Review of Stormwater Works

Blacktown Contributions Plan No.
22W (Rouse Hill)

Prepared for
IPART

12 October 2018

Figure 3-1 Comparison of Raingarden Costs

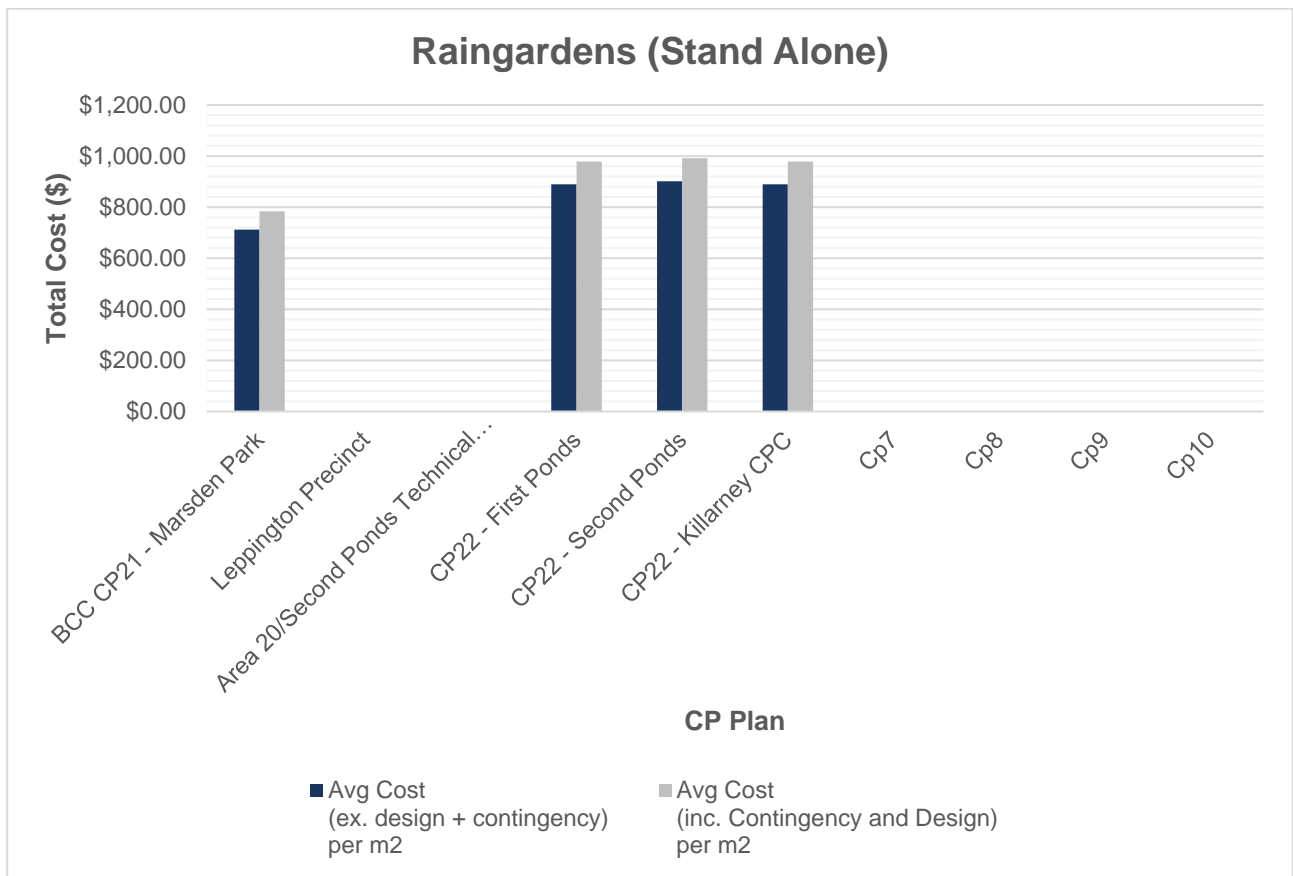
The average cost of raingardens was compared on a ‘per m² of filter area’ basis and the results are shown in **Figure 3-1**. This shows that the costs for raingardens are significantly higher in CP22 relative to CP21.

Figure 3-2 Comparison of GPT Costs

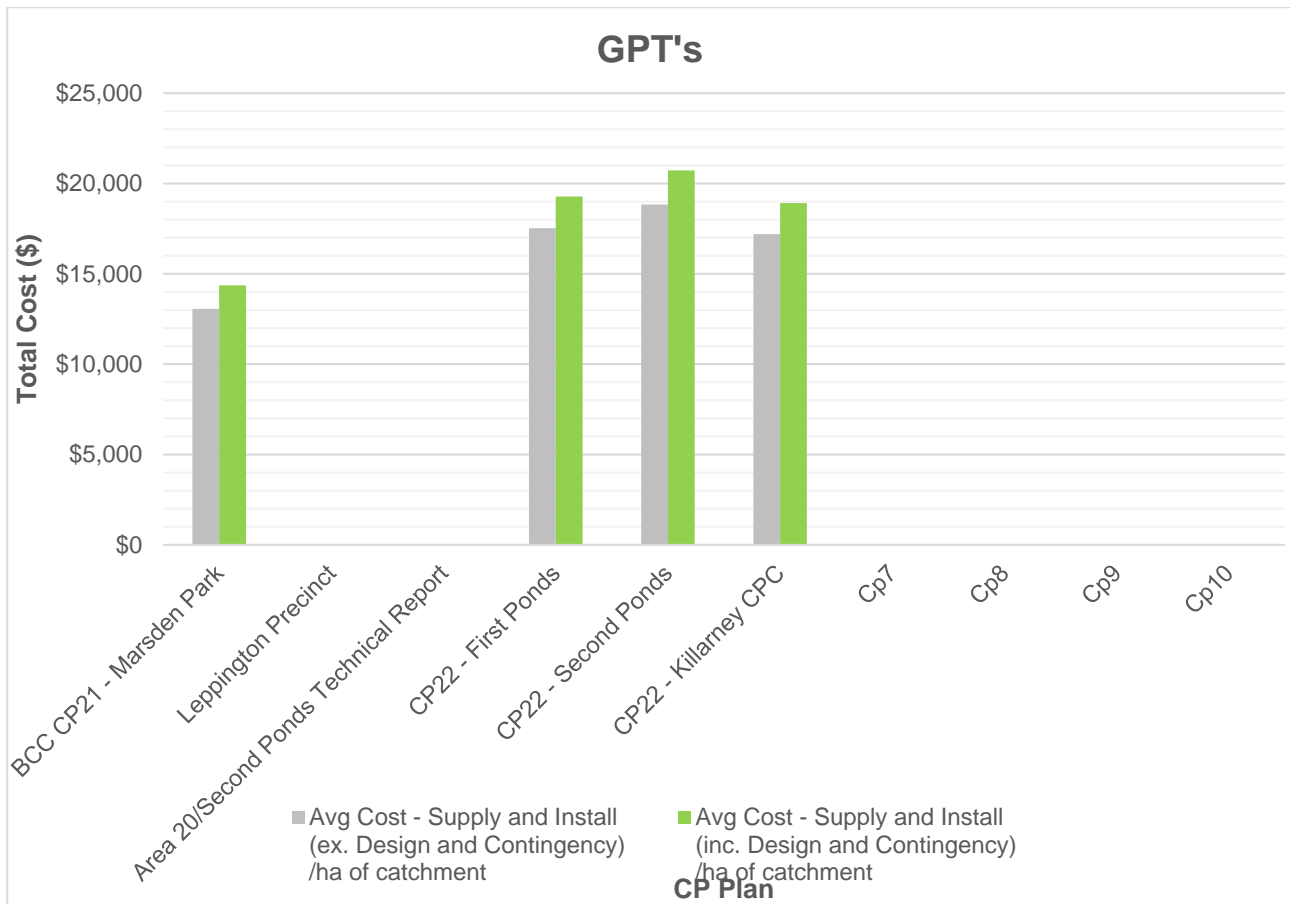
The total cost of GPTs was compared on a 'per hectare of catchment' basis was undertaken and the results are shown in **Figure 3-2**. This shows that the costs for GPT's are significantly higher in CP22 relative to CP21.

The greater relative cost is likely due to:

- the GPT units specified are generally larger than required (refer **Section 2**); and
- There has been a significant difference in the cost rates applied from CP21 to CP22 (approximately 15-20% increase for most units).

The increase in GPT unit sizes has been justified (refer **Section 2.2.2**), however the increased cost rates appears to be unreasonable. For a total GPT cost of approximately \$8.9m (including design and contingency), reducing the unit rates by 15% would reduce the total cost by approximately \$1.3m.

Table 3-1 Comparison of Detention Basin Costs

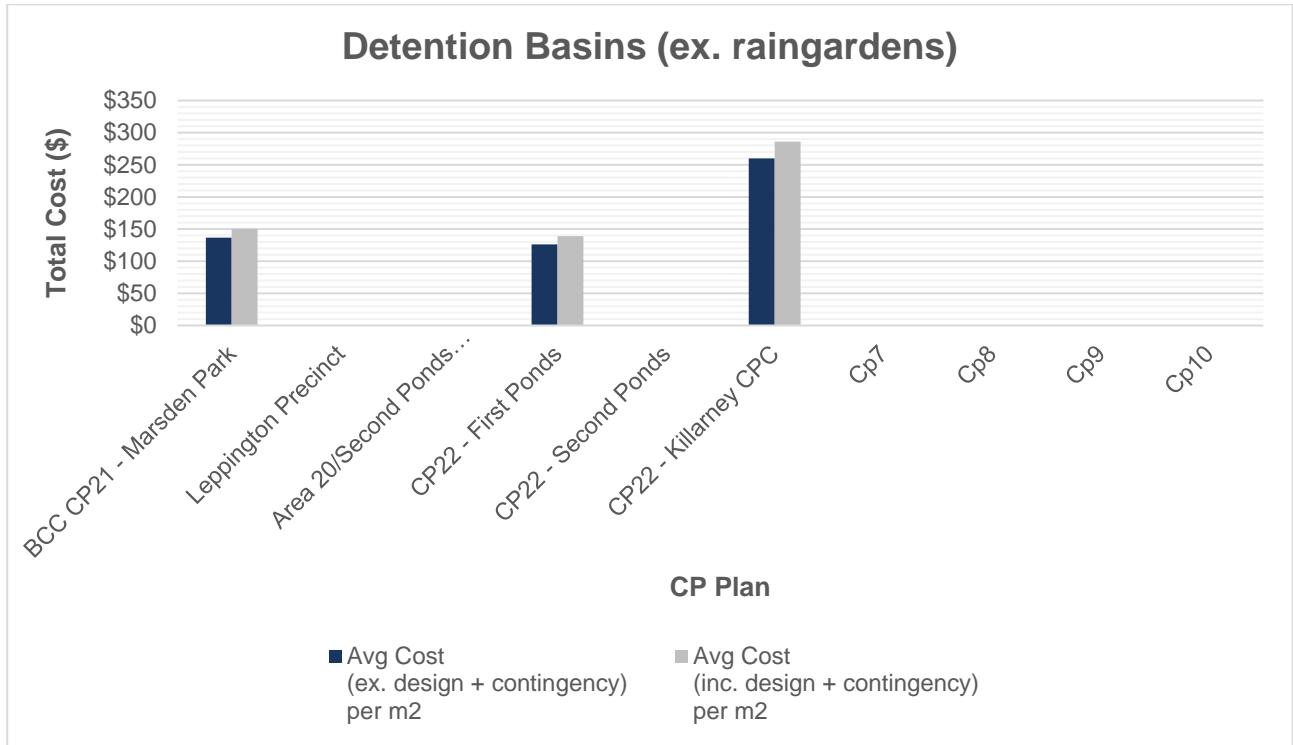
The average cost of detention basins was compared on a 'per m2 of overall site area' basis and the results are shown in **Figure 3-2**. This shows that the costs of detention basins in First Ponds Creek are comparable to CP21, however in Killarney Chain of Ponds Creek the costs are significantly higher. It is noted however that there is only a small number of detention basins

Figure 3-3 Comparison of Channel Costs

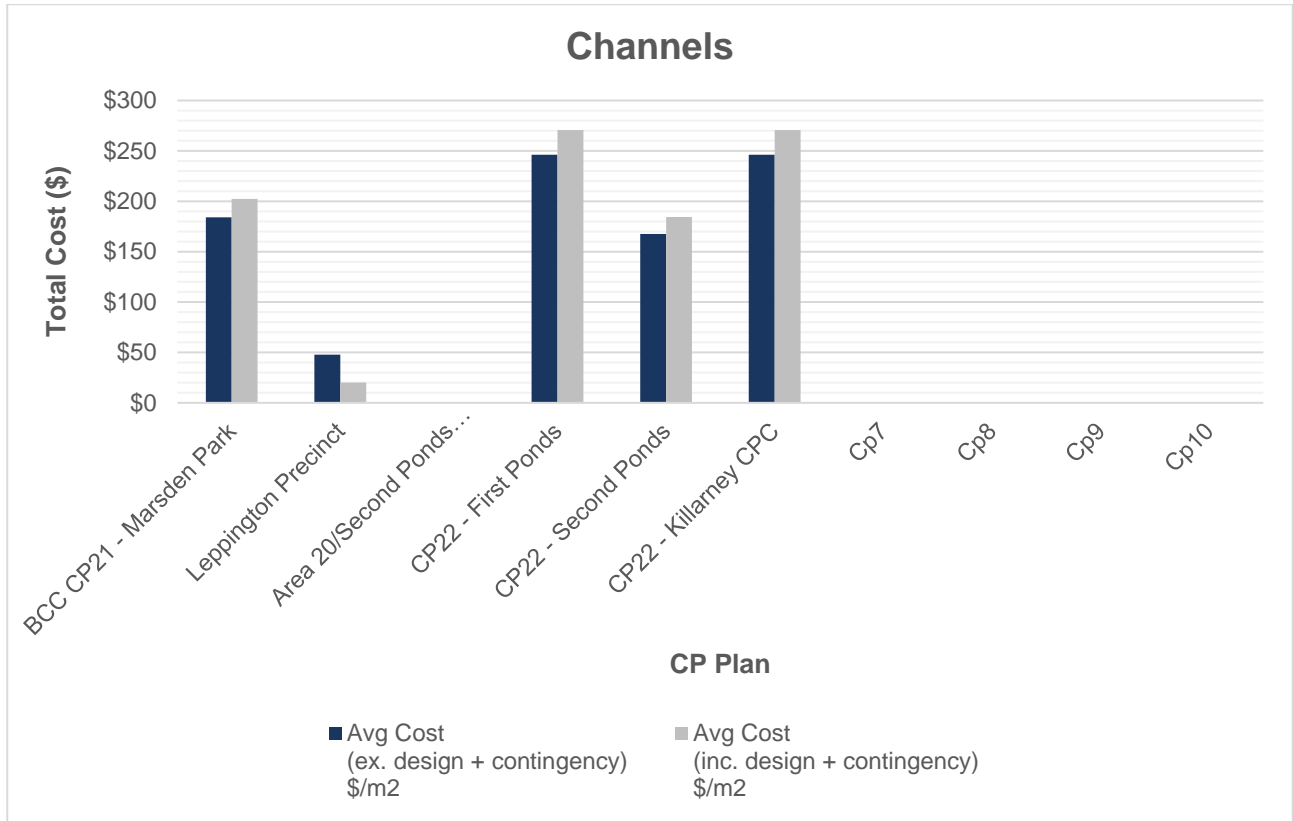
The average cost of channel was compared on a 'per m² of total surface area' basis and the results are shown in **Figure 3-3**. This shows that the costs of channels in First Ponds Creek and Killarney Chain of Ponds Creek are significantly higher than CP21. There are only two channels in Second Ponds Creek so there is limited value in this comparison.

Figure 3-4 Comparison of Culvert Costs

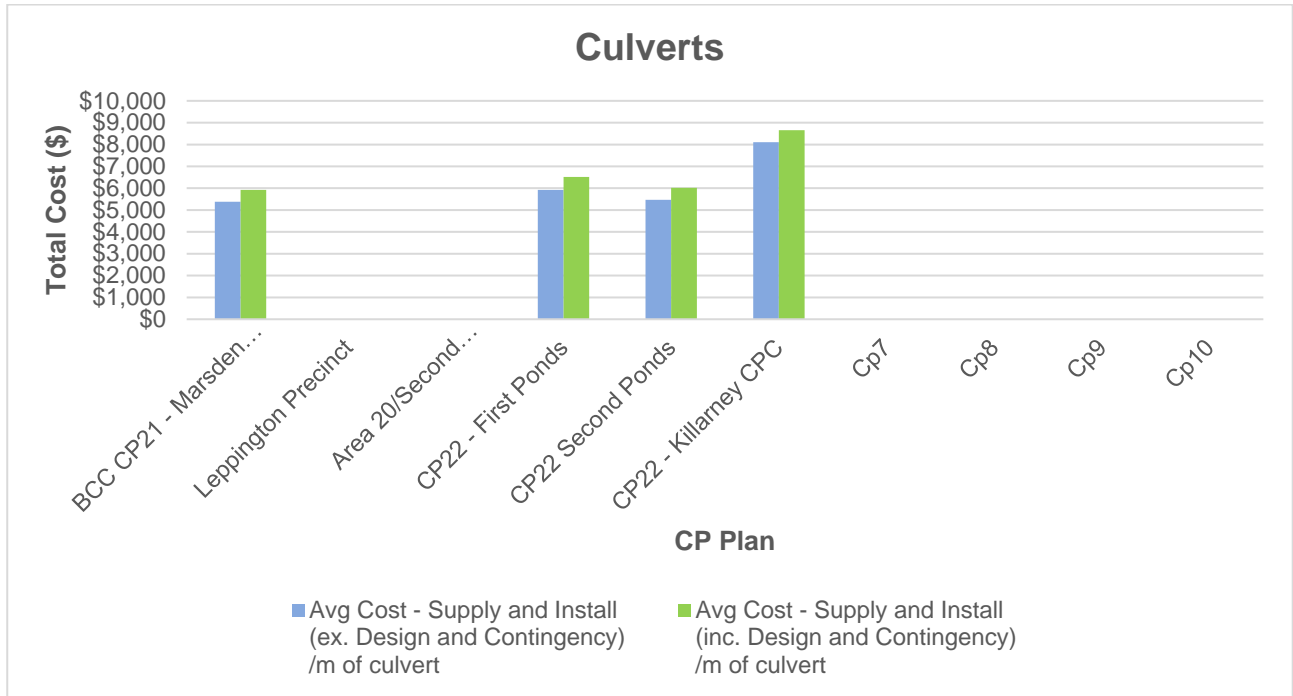
The average cost of culverts was compared on a 'per m of culvert length' basis and the results are shown in **Figure 3-4**. This shows that the costs of channels in Second Ponds Creek are similar to CP21, however First Ponds Creek costs are higher and Killarney Chain of Ponds are significantly higher.
